Following are comments on the Rammed Aggregate Pier (RAP) submittal for Seaside:

TITLE: AGGREGATE PIER PLAN
PROJECT: SEASIDE REHABILITATION
LOCATION: PORTLAND, ME
DATE: 12/7/2012
SCALE: AS NOTED

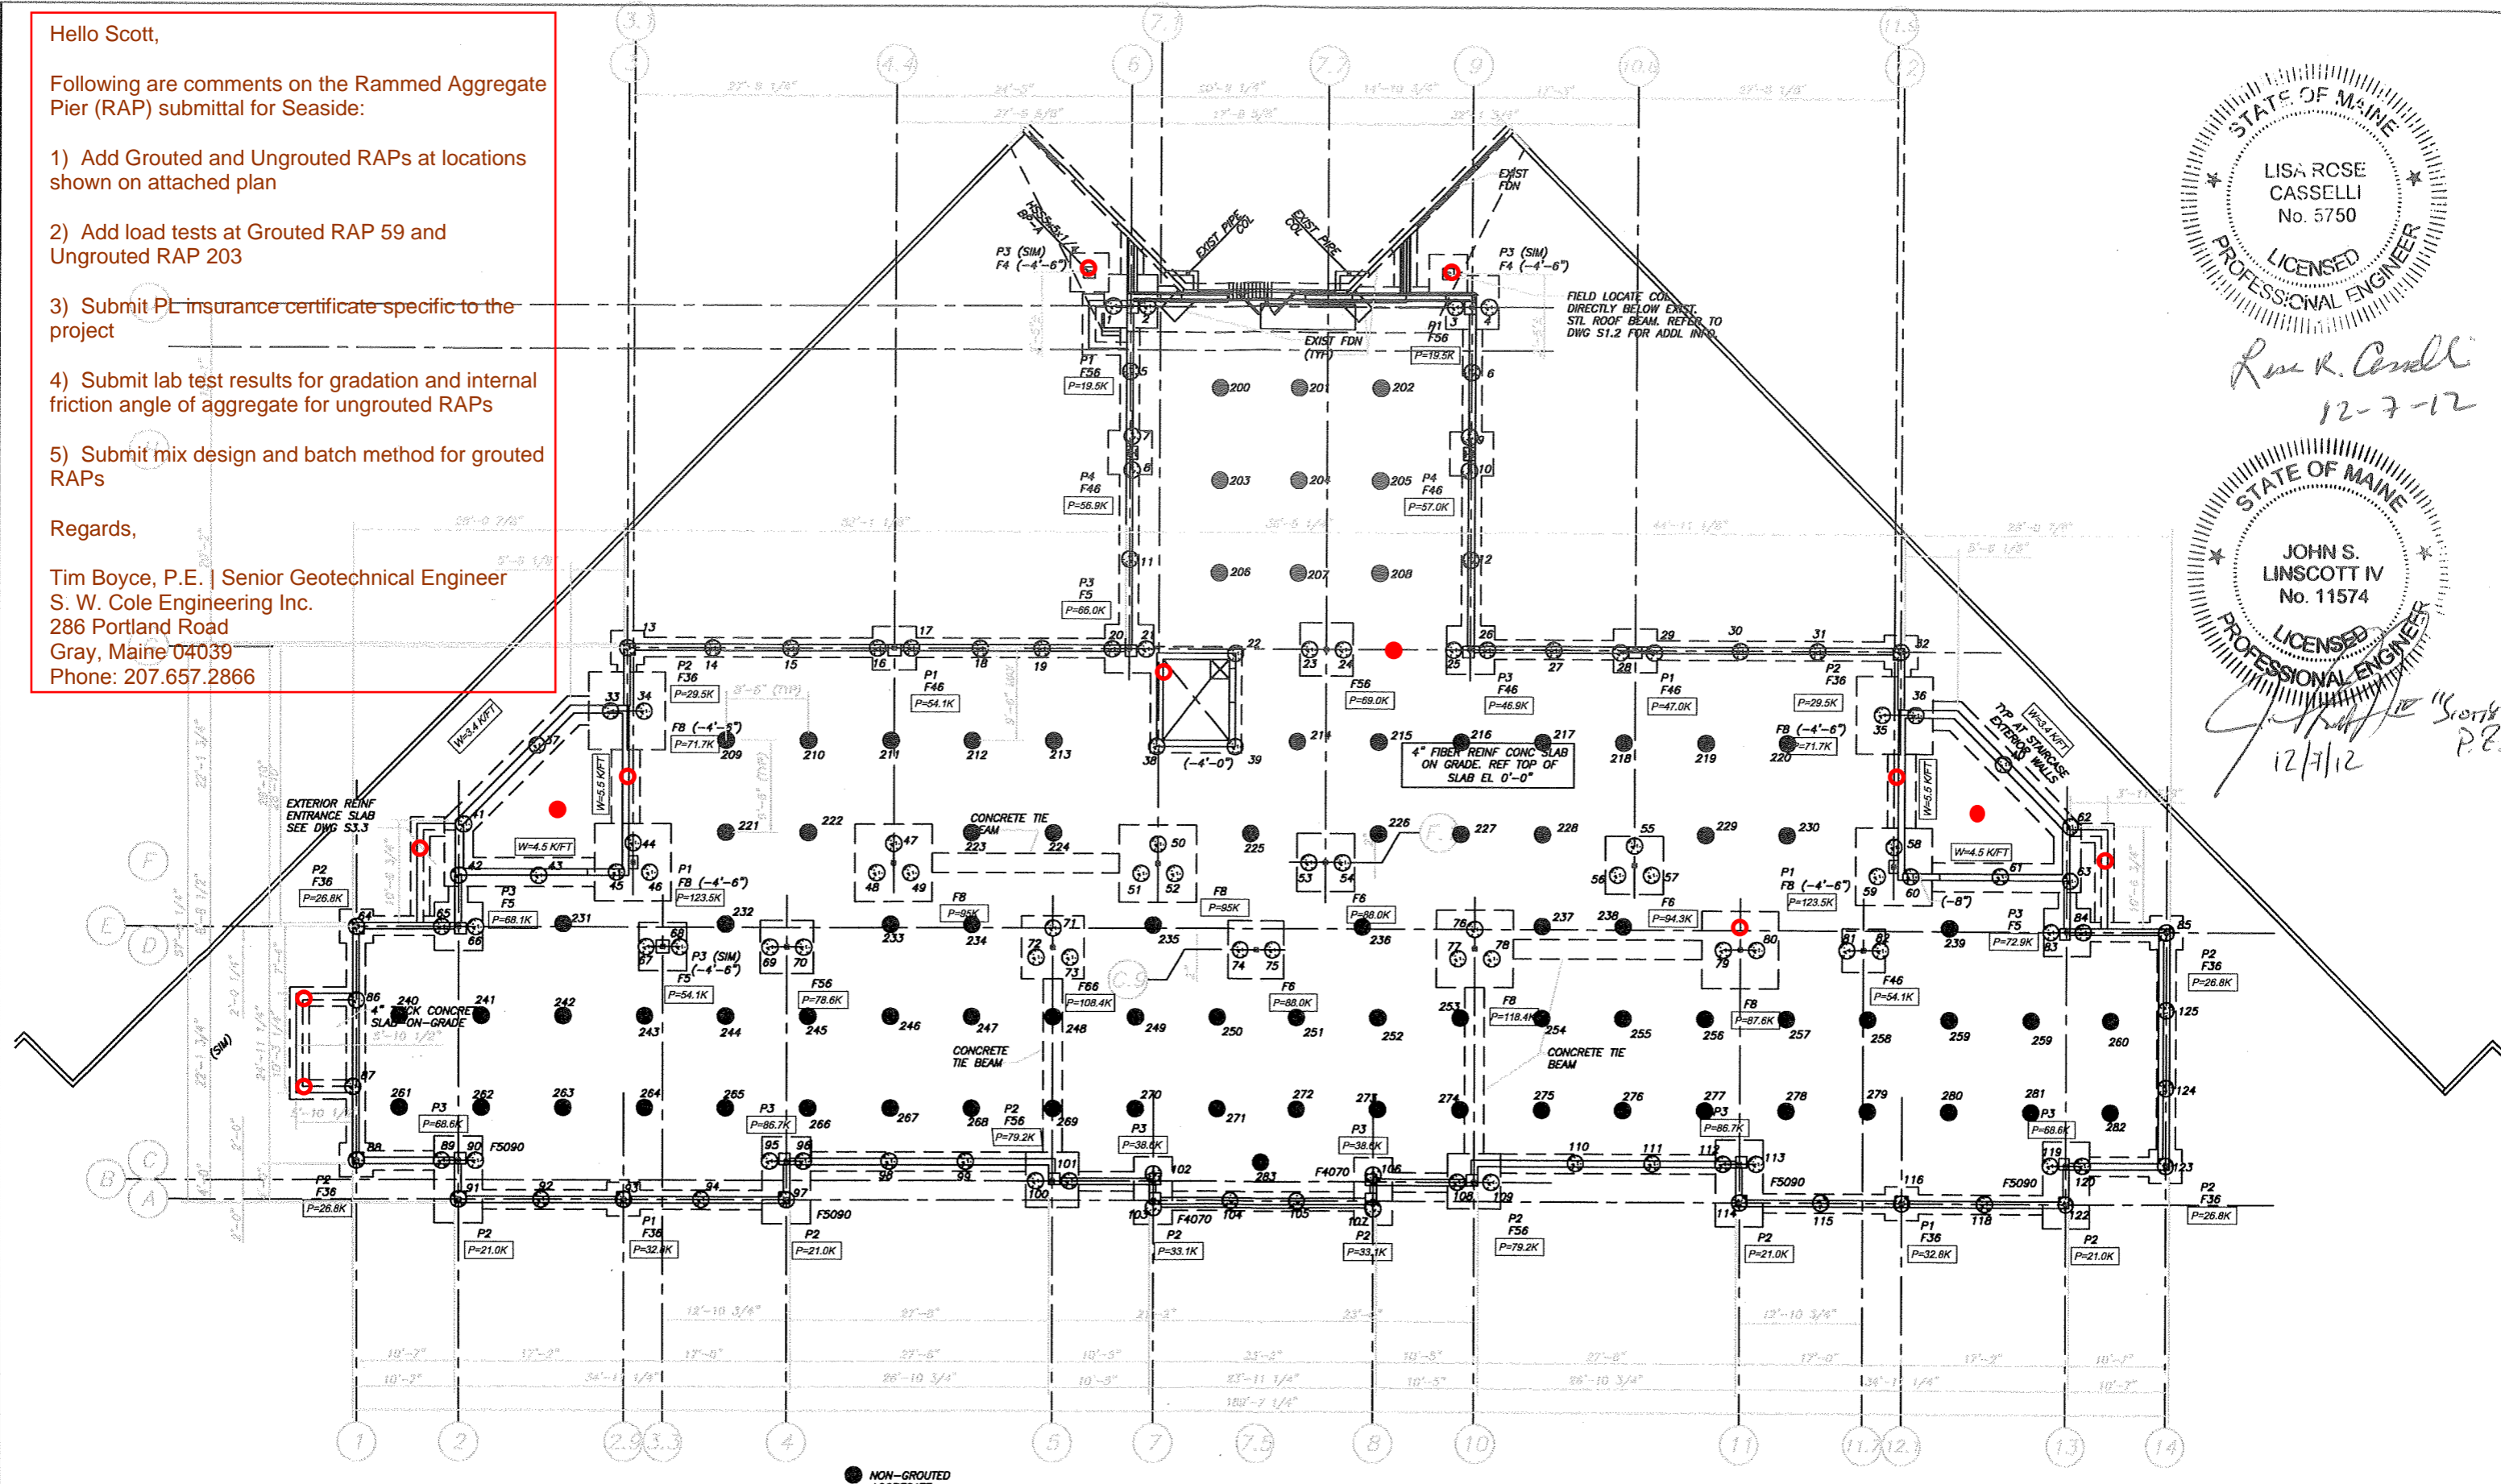
- 1) Add Grouted and Ungrouted RAPs at locations shown on attached plan
- 2) Add load tests at Grouted RAP 59 and Ungrouted RAP 203
- 3) Submit PL insurance certificate specific to the project
- 4) Submit lab test results for gradation and internal friction angle of aggregate for ungrouted RAPs
- 5) Submit mix design and batch method for grouted RAPs
